MODIFICATION BULLETIN NO. FX7-001

Model	FAX 1700L					Date of Modification	
Modified Article	ADF					Execution Date	
Reason for Modification	<div style="display: flex; justify-content: space-between;"> <div> <input checked="" type="checkbox"/> Parts catalog correction <input type="checkbox"/> Vender change </div> <div> <input type="checkbox"/> To meet standards () <input type="checkbox"/> Part standardization </div> <div> <input type="checkbox"/> To facilitate assembly <input type="checkbox"/> To improve reliability <input type="checkbox"/> Other </div> </div>

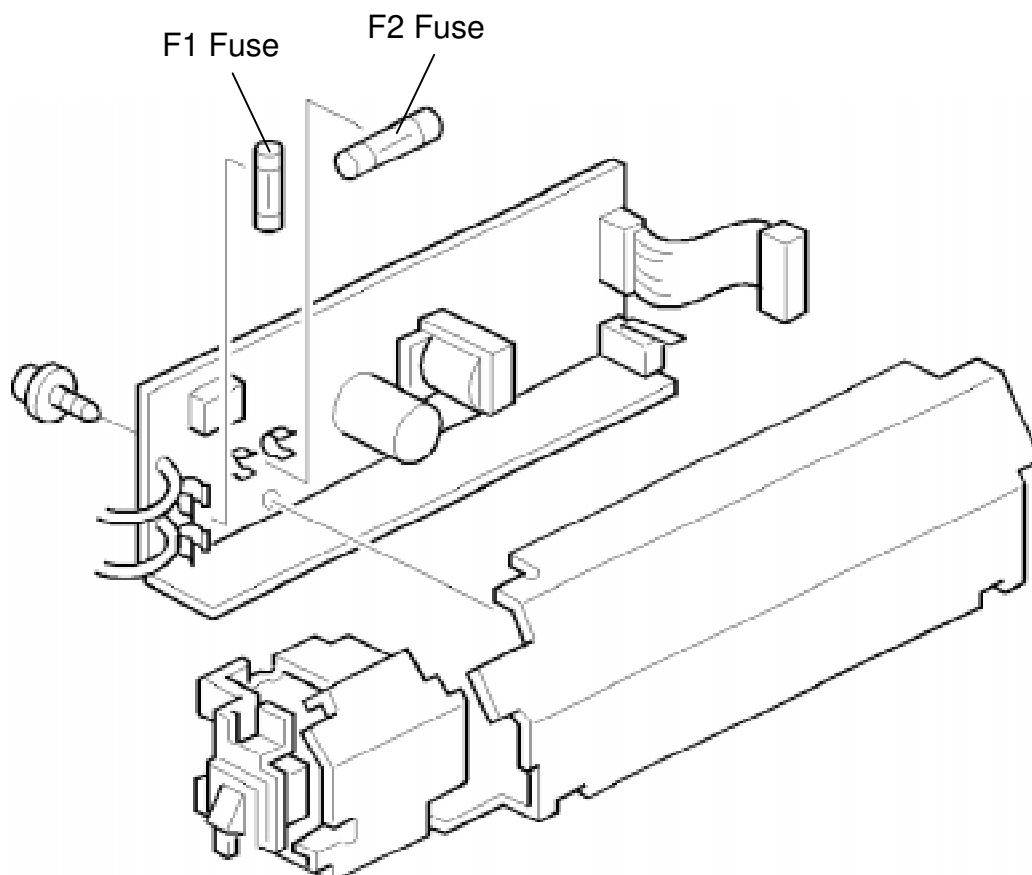
Old part number	New part number	Description	Qty	Int	Page	Index	Note
H5291155	H5291157	Document Friction Plate	1→1	X/O	5	9	Below
H5291148	H5291158	Friction Lever	1→1	O/X	5	10	Below

The interchangeability of these parts is "X/O" in combination.

(Both the friction plate and the lever need to be replaced when either H5291155 or H5291148 is replaced)

1.EXTERIOR INDEX NO.11

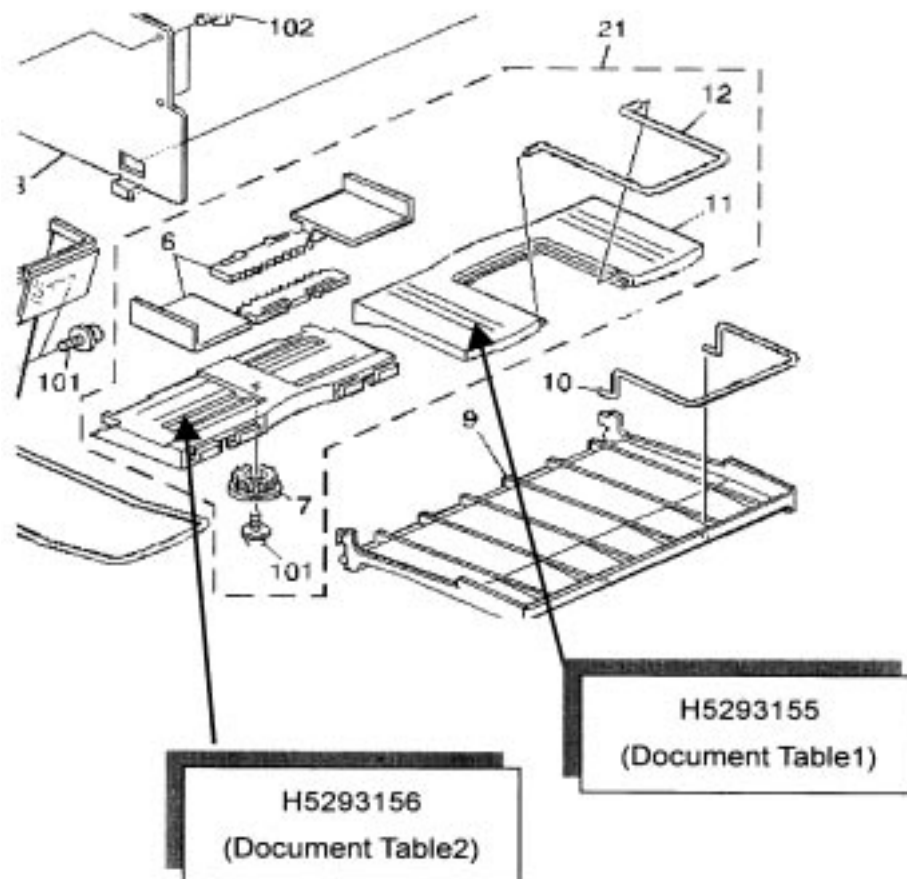
Status	Parts Number	Description
Current	H529 3156	Document Table
Correction	H529 3155	Document Table 1
	H529 3166	Document Table 2

Please refer to the diagram.

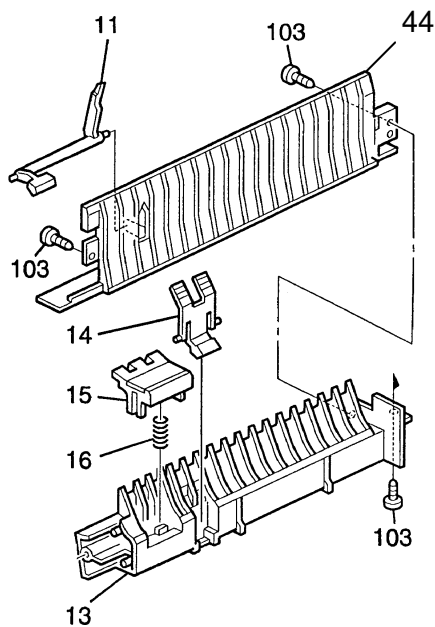
Old part number	New part number	Description	Qty	Int	Page	Index	Note
-	V01028800	Paper Guide	1		15	44
